HOWELL SUBDIVISION

APPLICATION NUMBER 7 DATE June 5, 2014

REQUEST Subdivision

DETAIL SITE PLAN

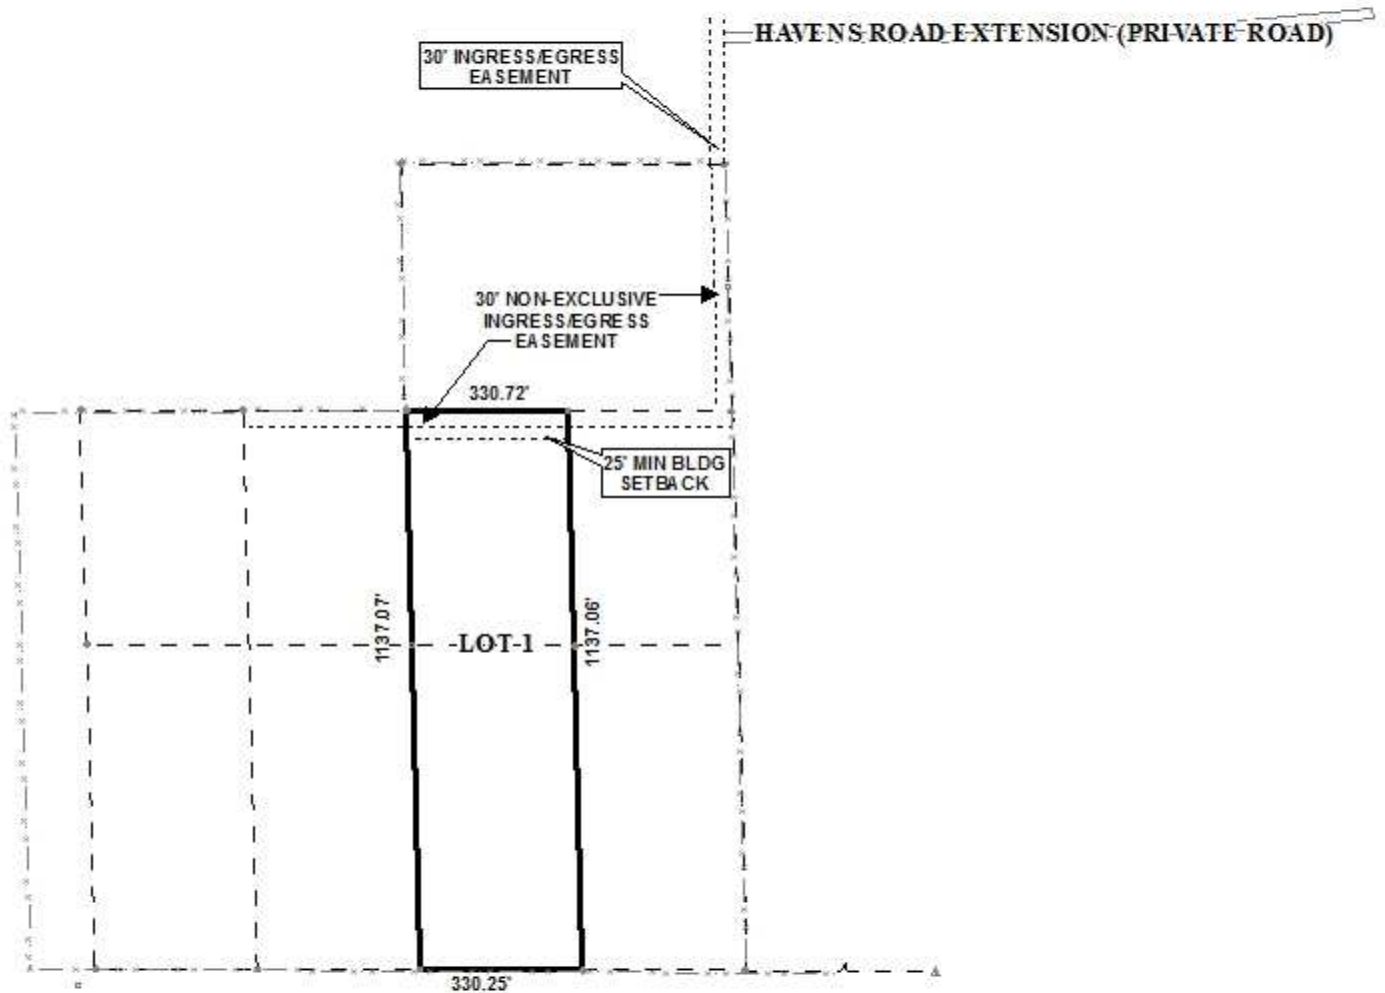
Section V.D.9. of the Subdivision Regulations requires the provision of a 25-foot minimum building setback from the "front property line," which in this case, staff has determined to be where the recorded easement enters the site. As on the preliminary plat, the 25-foot minimum building setback should be illustrated as measured from the 30' ingress/egress easement.

The proposed lot meets the minimum size requirements of the Subdivision Regulations; however, the lot is not labeled with its size on the preliminary plat. Therefore, the plat should be revised to label the lot with its size in square feet and acres, or a table should be furnished on the Final Plat providing the same information.

As the site abuts a private road, any curb-cuts for the site should comply with Mobile County Engineering requirements.

- 1) retention of the 25' minimum building setback line as measured from the 30' ingress/egress easement;
- 2) revision of the plat to label the lot with its size in square feet and acres, or the furnishing of a table on the Final Plat providing the same information;
- 3) placement of a note on the Final Plat stating that any curb-cuts for the site should comply with Mobile County Engineering requirements;
